PROJECT NO. BA-688-200-001
Supreme Court of Maryland

ADDENDUM # 2

ADDENDUM # 3

This Addendum includes questions and answers.

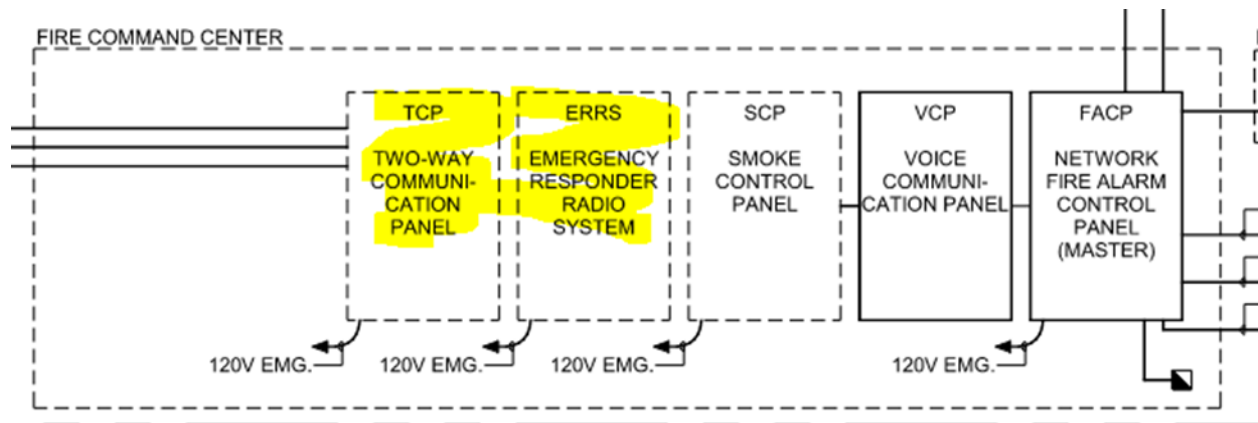
Question #14: Wondering if you could verify that there are certain products that you're asking for Buy American Act compliance. I am asking seeing that when I did a global search for "Buy American Act" I only had one (1) match on page 128, and it was Module UPJ2-2B (BAA-Buy American Act Compliant). b. 3-Button Control; Lutron Pico Wireless Control Model PJ2-3B; or Lutron Pico Wireless Control Module UPJ2. No other reference. I don't like to assume, so are there no federal funds being used that required BAA? This would help with lowering the cost.

Answer #14: The State of Maryland – Department of General Services General Conditions for Construction Contracts – July 1, 2022. On Page 31 - 5.03 – BUY AMERICAN STEEL The Contractor must comply with the requirements of the Maryland Buy American Steel Act, Title 17, Subtitle 3 of SF&P and COMAR 21.11.02, which are incorporated into and made a part of the contract.
